Case No. P/O 185 of 1932.

BUILDING SURVEYOR'S REPORT.

PLAN OF ADDITIONS & ALTERATION
ON TOP FLOOR TO BE BUILT
PLOT NO 63+64 SHEET NO 41 & 6
JAIL QUARTER
SCALE 8"=1" INCH

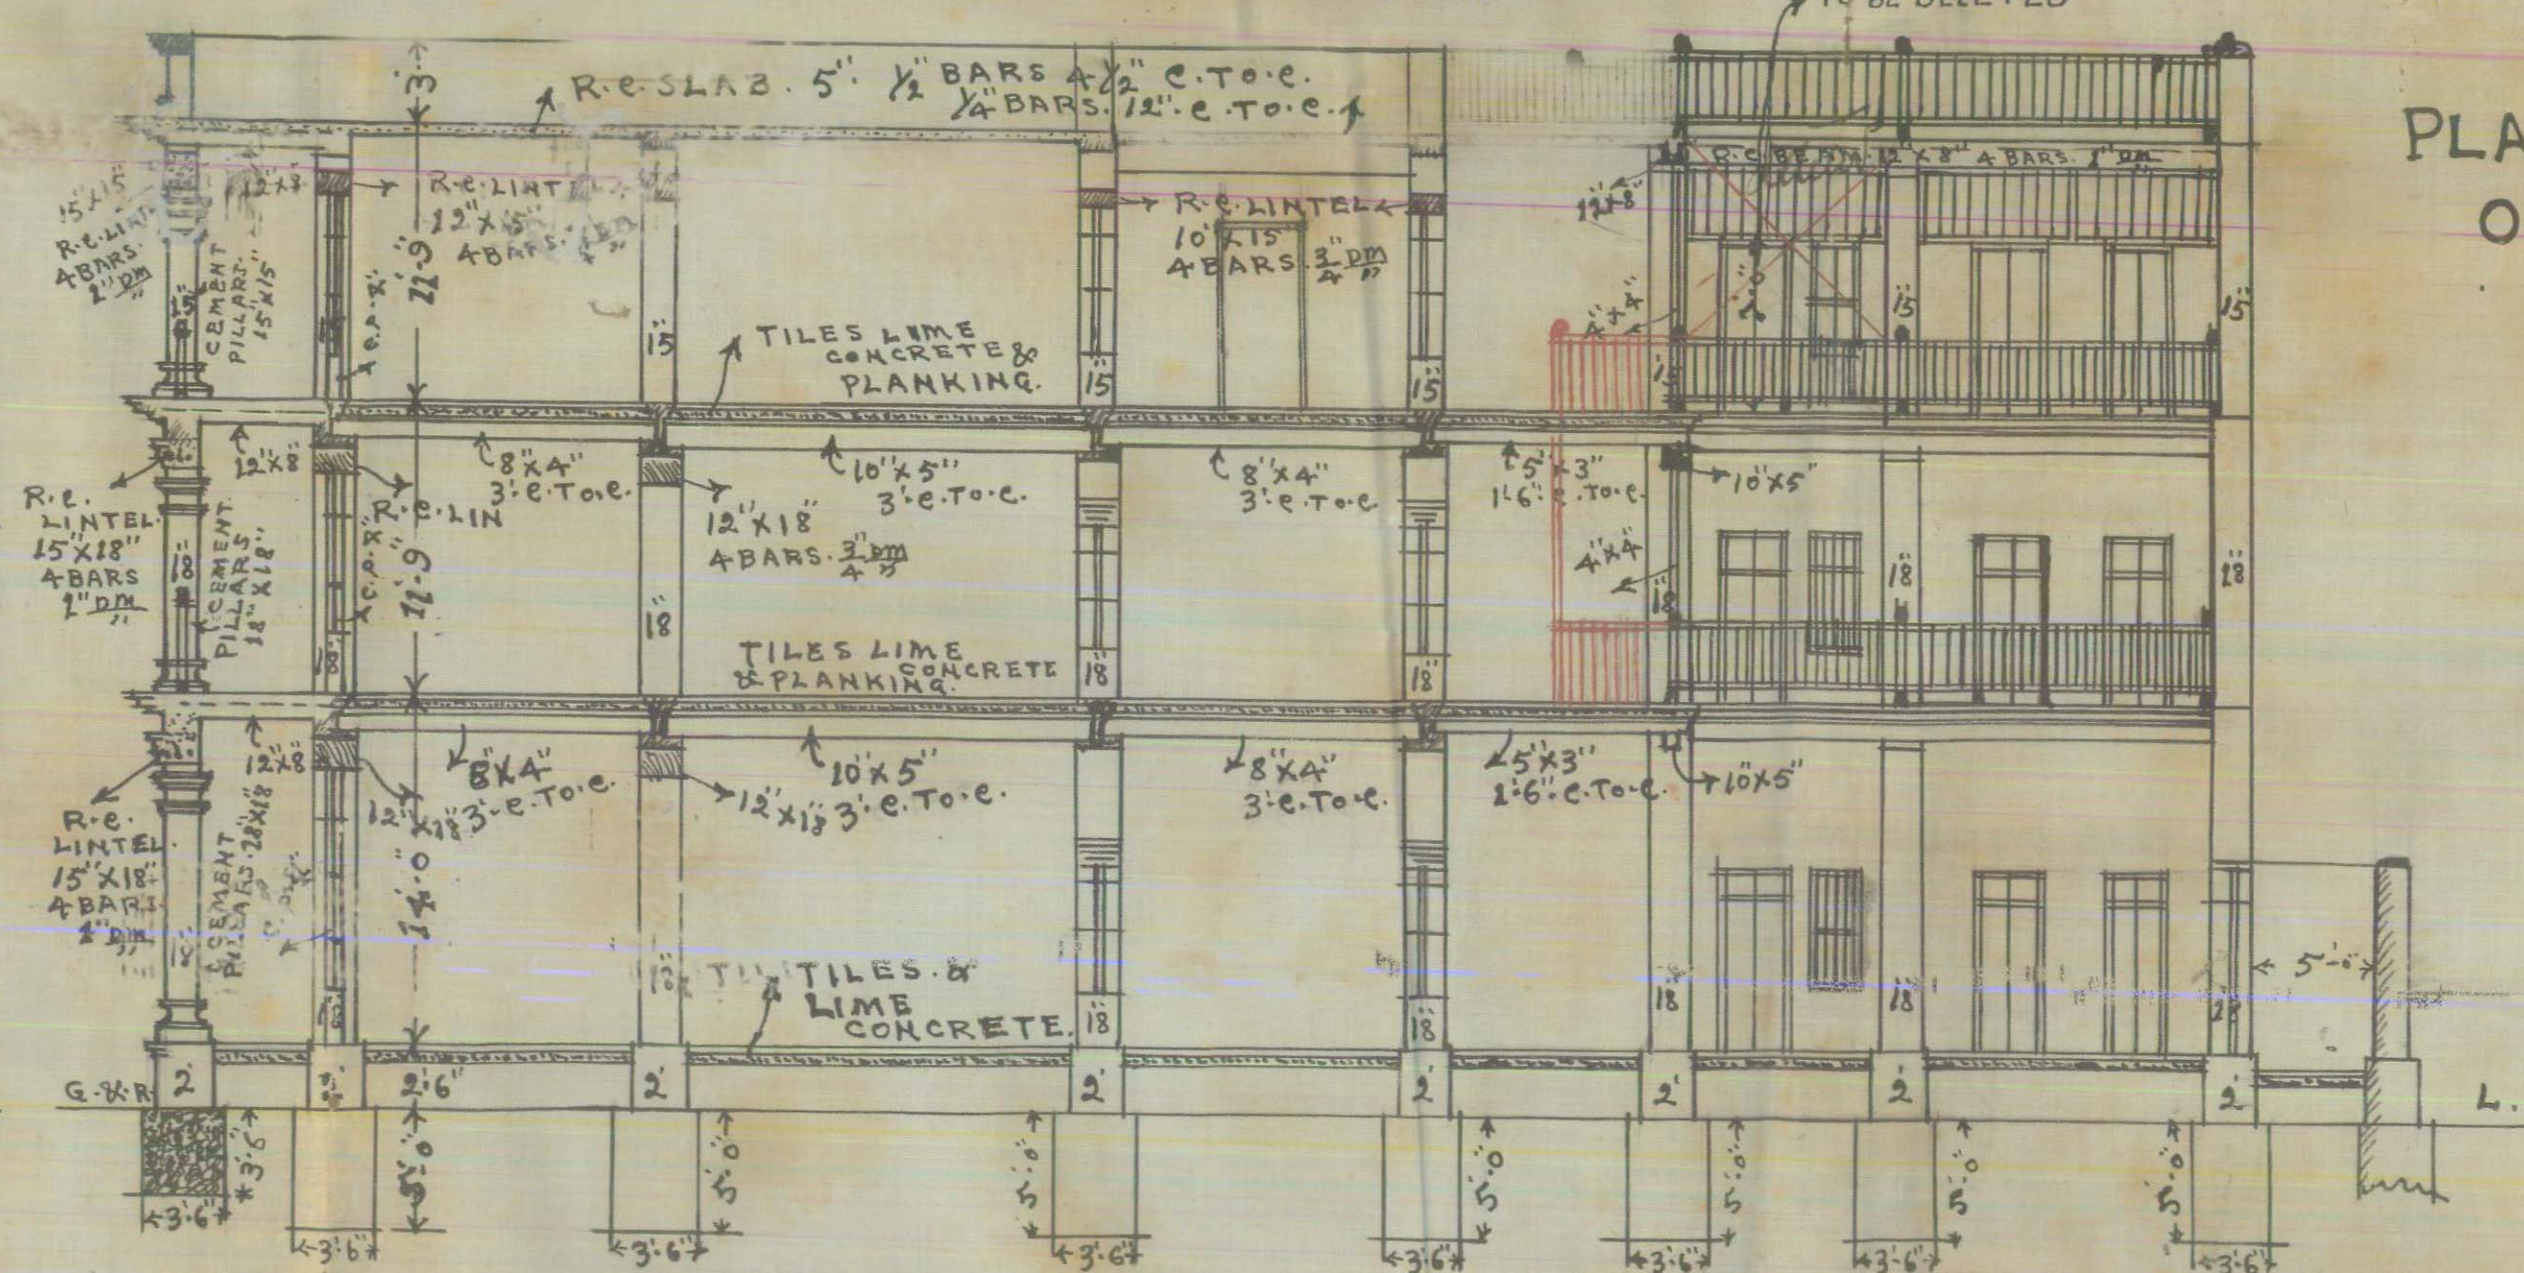
- (1) Inner rooms & the interior of the hall require to be properly ventilated. Attempts be made to increase air & light
- (2) ^{Roof} Roof of Sanitary block for the proposed floor be ~~given~~ mentioned in the plan.
- (3) Foundation to be exposed for inspection
- (4) The proposed arrangement for stairs is very satisfactory. The stairs must be in the same place where it exists at present.
- (5) Windows be provided from the wall facing the landing to increase air & light of the rooms.

Please ask them to submit plan of
subdivision for Shown's address & also
B.S. & also other. The design must be altered to
secure for the road adequate light & air, 9' deep
road also along. The existing boundary is
dark. Indicate mark of
exposed for inspection 8/5/32

- (1) *Sub division plan showing addition & alteration must be submitted.*
- (2) *Inner room of the interior of the hall requires to be properly ventilated, attempts to be made to increase air & light.*
- (3) *Foundation of roof of Sanitary block for the proposed floor be mentioned in the plan.*
- (4) *Foundation to be exposed for inspection.*
- (5) *The proposed arrangement for stairs is not satisfactory. The stairs must be in the same place where it exists at present.*
- (6) *blinds and be provided from the wall face the landing to increase air & light of the room.*
- (7) *Site measurements must be corrected.*
- (8) *Plans must be amalgamated & submitted clearly.*
- (9)

amended
(1) The design must be altered to secure for the room adequate light & air.
(2) 9' open would not do at all
(3) The existing building is dark.

(1) Subdivision plans have been sent to C.D.C and plot no 61 can not be amalgamated as it is held on a different lease.

(2) Open space and reducing the width of verandah will increase light & ventilation as suggested by you

(3) Nature of roof of proposed sanitary block is shown on plans

(4) Foundations are exposed which may be inspected by B.S.

(5) You were good enough for personal interview to retain the proposed stairs as it is now lighter on both

(6) Side measurements are corrected

(8) Design has been altered and adequate light & air provided

(9) 9'-0" open has been existing building proper passages will be open to sky

(10) Light has been provided in the veranda
Yours faithfully
Devkishindas
